Z-63
(2013)

SCALE
FULL SCALE
DRAWING TITLE
ZONING PLAN
DRAWING NUMBER
C-01
PLAT DATE: 10/2013

PETITION NO: Z-63

ZONING COMMENTS:

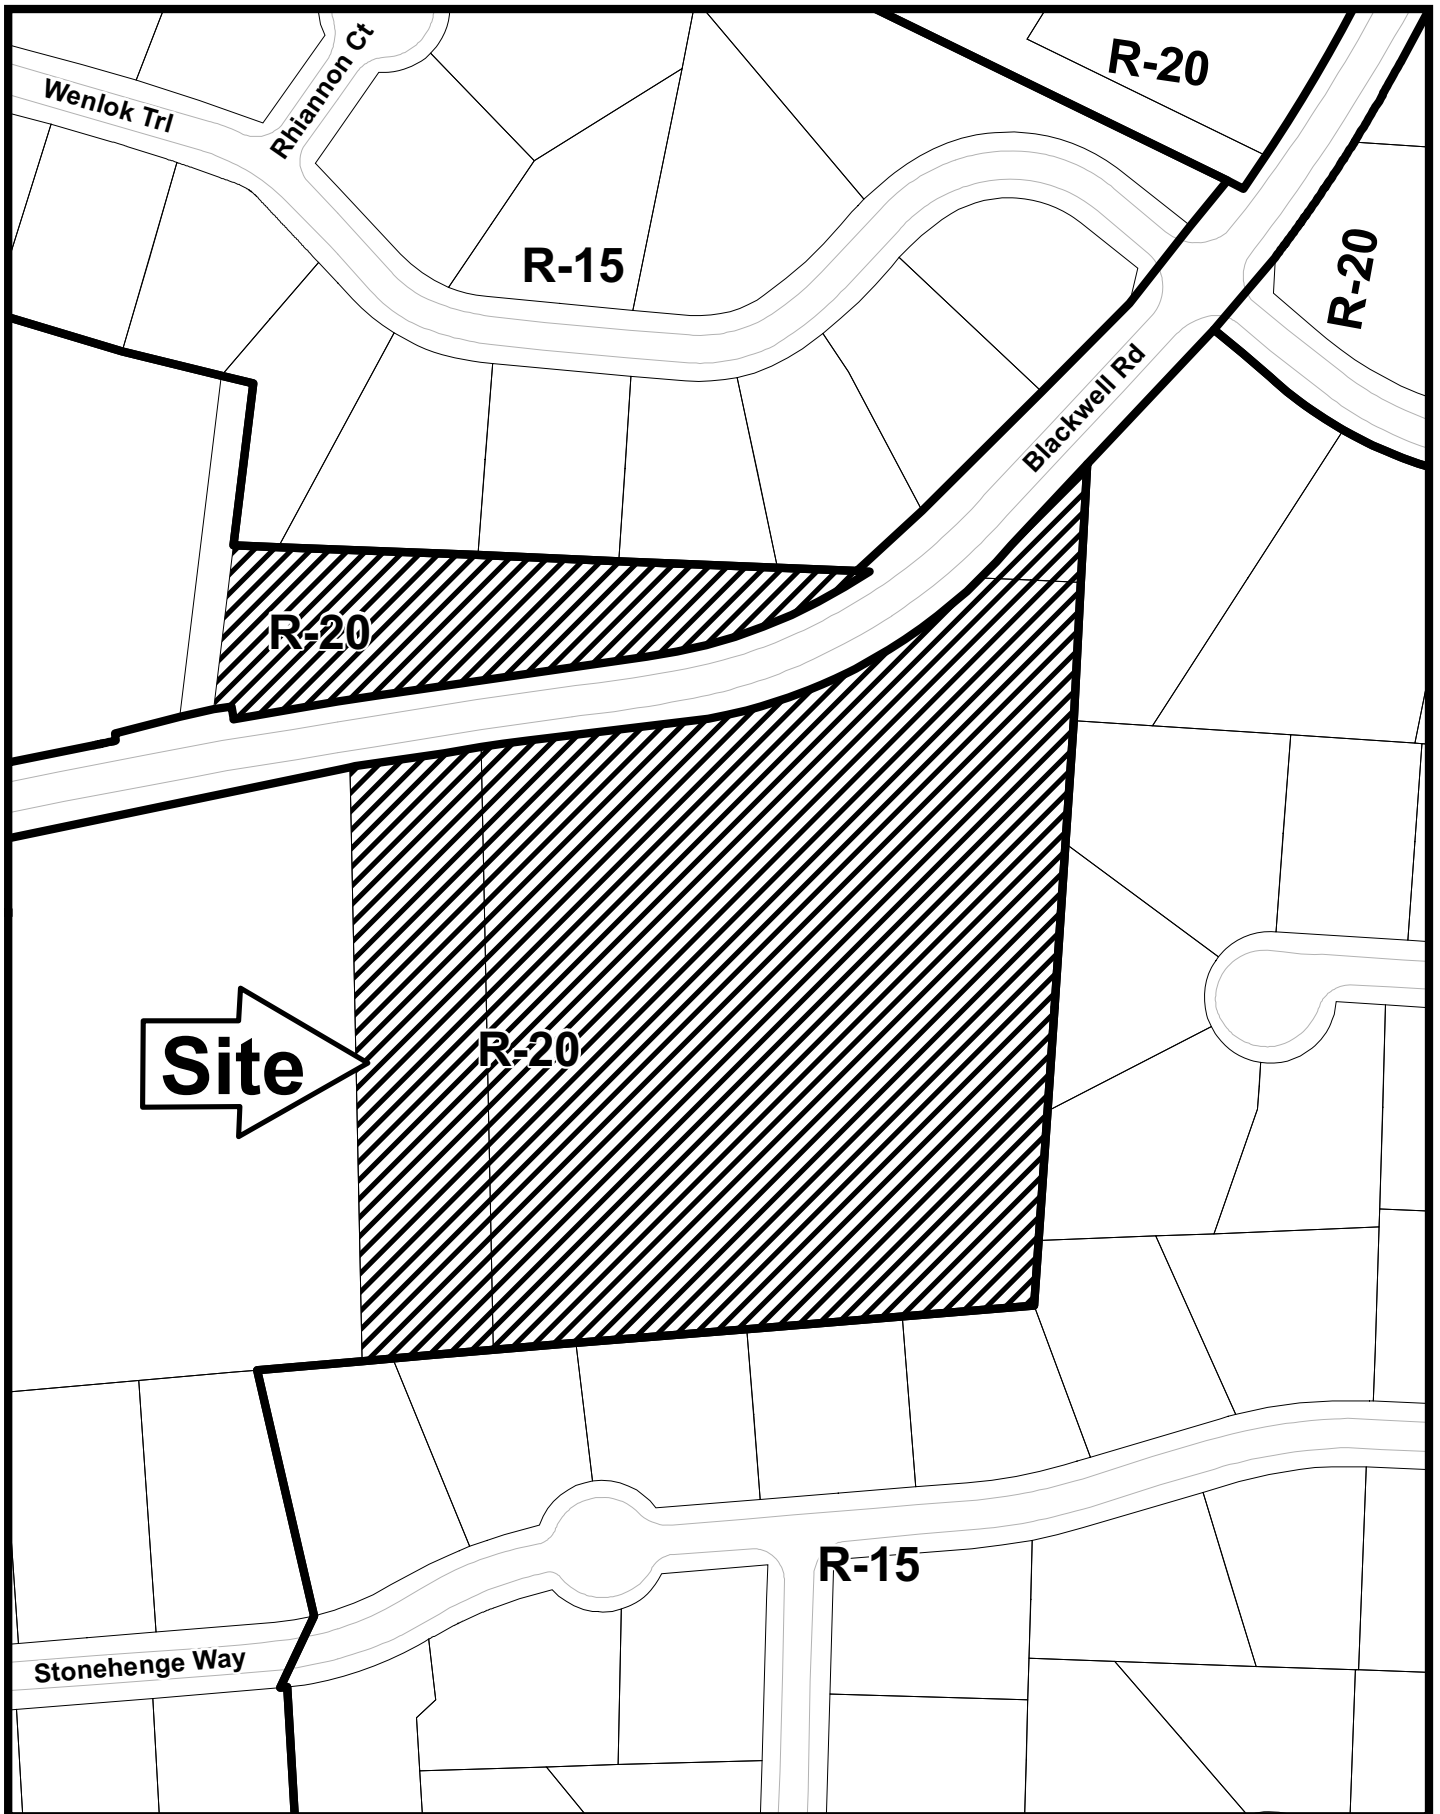
Additional Comments: 10' setback from the sewer easement for permanent structures is required for lots 4 through 7

1. The majority of this site is being preserved as green space, including the portion to the north of Blackwell Road as well the steeply sloped area to the south of the existing sanitary sewer easement and stream buffer. The site drains to the west through an adjacent residential parcel to the Rubes Creek floodplain.
2. A 20-foot drainage easement will likely be required at the rear of lots 2 & 3 to direct runoff to the proposed detention pond and limit offsite bypass.

Recommend a shared access for lots 6 and 7.

1. All open space must be on same tract of property.
2. Detention Pond facility must be outside of open space area and cannot be calculated as open space.

3. For exterior lots 2 and 3 the rear setback must meet or exceed that of the adjacent zoning which in this case is R-20. For exterior lot 7 the rear setback must meet or exceed that of the adjacent zoning which in this case is R-15.

6. As another form of privacy barrier staff recommends installing fence to the rear of lots that area adjacent to open space
7. Must have Cobb Department of Transportation approved lighting plan in if outdoor lighting (except individual residential lots) is proposed
